Project	IEEE 802.16 Broadband Wireless Access Working Group < http://ieee802.org/16 >		
Title	Signaling using the energy keying in the frequency domain		
Date Submitted	2006-02-28		
Source(s)	Mariana Goldhamer Alvarion 21, HaBarzel Street Tel Aviv, Israel	Voice: Fax: mailto: mariana.goldhamer@alvarion.com	+972 544 22 55 48 +972 3 6456241
Re:	IEEE 802.16h-06/005 – Call for Contributions		
Abstract	Fixes the addressed chapter		
Purpose			
Notice	This document has been prepared to assist IEEE 802.16. It is offered as a basis for discussion and is not binding on the contributing individual(s) or organization(s). The material in this document is subject to change in form and content after further study. The contributor(s) reserve(s) the right to add, amend or withdraw material contained herein.		
Release	The contributor grants a free, irrevocable license to the IEEE to incorporate material contained in this contribution, and any modifications thereof, in the creation of an IEEE Standards publication; to copyright in the IEEE's name any IEEE Standards publication even though it may include portions of this contribution; and at the IEEE's sole discretion to permit others to reproduce in w

Figure h1. Desired spectral densities for different channel BWs

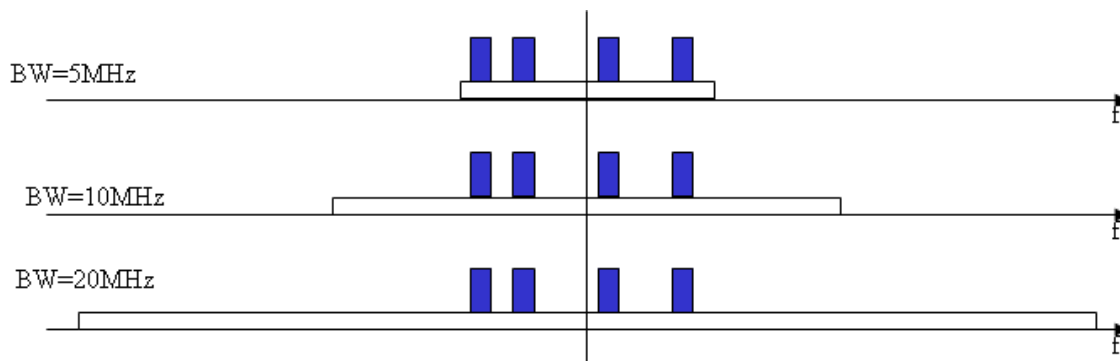
The following figures show the desired spectral density for cognitive radio signaling. Independent of the actual channel width, the preambles are sent using the narrowest channel possible in the band. In the following example, in which channels of 5, 10 and 20MHz may be used, the narrowest channel is 5MHz and any other system will be able to detect the preambles, which are not attenuated by any radio filter, and the possible outcome of the MAC PDU approach, introducing some distortions in time or frequency domain, but still detectable by non-802.16 systems. The narrowest channel will be centered in the frequency domain around the actually used channel center.

Figure h2. Obtainable spectral densities with MAC PDU approach

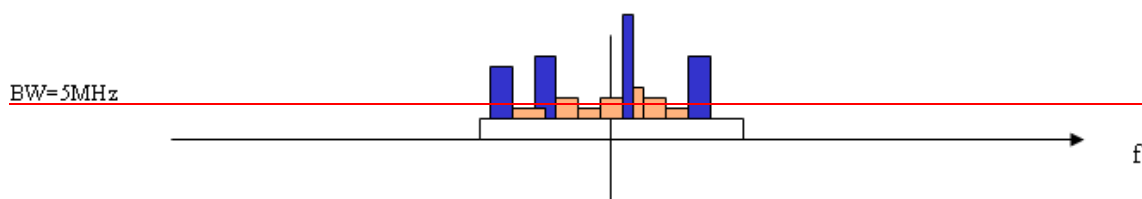
Due to the FFT guard sub-carriers, not all the bins are usable; we will use in continuation, from the bins numbered 0...31, where the bin#0 corresponds to the lowest frequency, only the bins 6...26. The MAC PDUs, having the spectral characteristics defined in the Table x, are defined in Chap. t.b.d for each of the 3 802.16 PHY modes.
